INNER WEST COUNCIL

DEVELOPMENT ASSESSMENT REPORT

Application No.	DA201700110.02
Address	109-111 Parramatta Road, Camperdown NSW 2050
Proposal	Application under Section 4.55(2) of the Environmental Planning and Assessment Act to modify Determination No. 201700110.01 dated 21 February 2018 to add a fifth floor to the approved 4 storey mixed use building; delete car stackers and construct a basement level car park; reconfigure all floors to accommodate a lift and new atrium.
Date of Lodgement	30 August 2018
Applicant	Acemon Pty Ltd C/- CMT Architects Australia
Owner	Acemon Pty Ltd
Number of Submissions	13 submissions objecting to the modified development
Value of works	\$3,687,978.00
Reason for determination at Planning Panel	<ol style="list-style-type: none"> 1. This application is the subject of 10 or more unique submissions by way of objection. 2. State Environmental Planning Policy No 65- <i>Design Quality of Residential Apartment Development</i> applies and is 4 or more storeys in height. 3. The proposed modified development contravenes a development standard imposed by an environmental planning instrument by more than 10% or non-numerical development standards.

Figure 4: Photomontage showing the relationship of the **approved** development on the site against the approved development on the adjoining site to the west, 113-117 Parramatta Road.

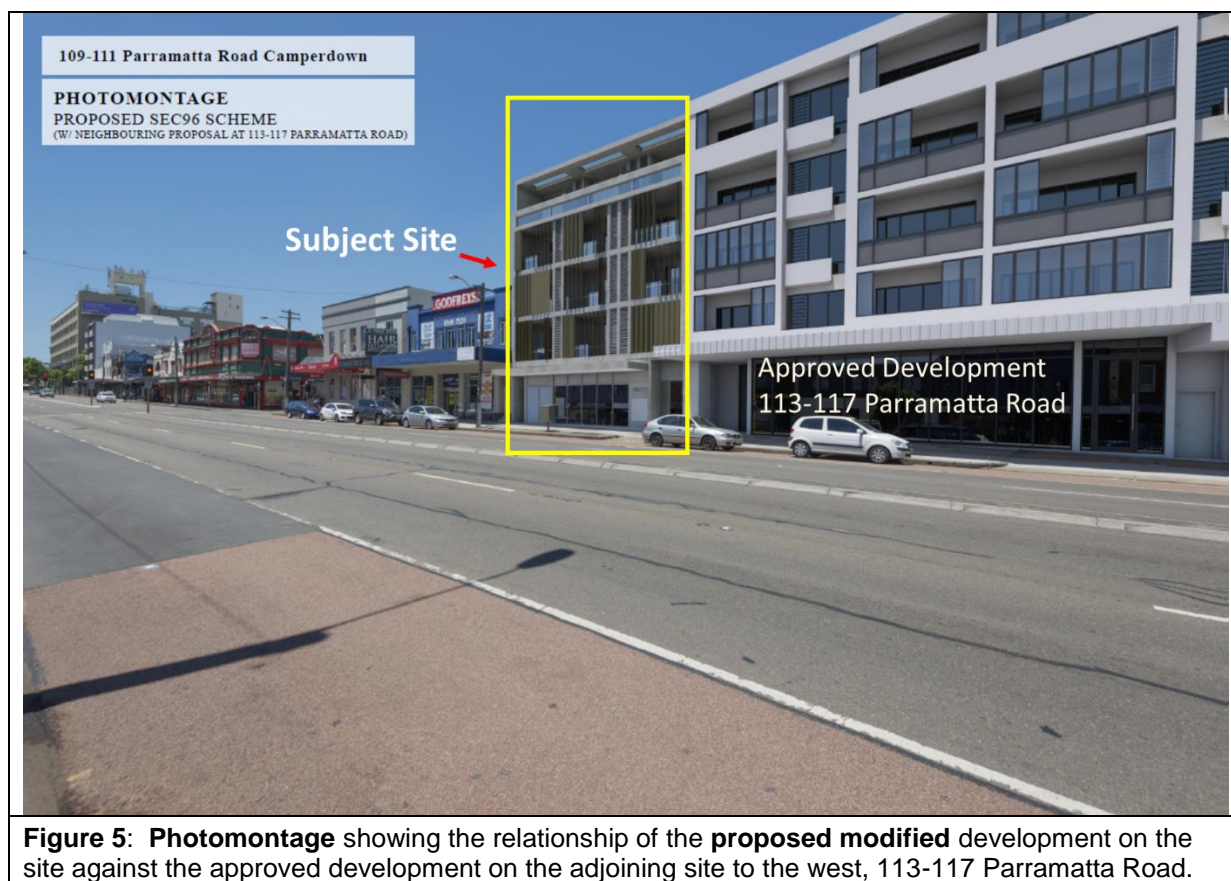
04.07.2019	<p>Applicant submitted the requested additional information requested by the AEP. Submitted drawings provide a diagrammatic response to the three points raised by the AEP regarding 3D massing, solar access and privacy to the adjoining properties, and clarification of the upper building envelope. Submitted photomontages of the revised proposal are included as Figures 4, 5 and 6.</p>
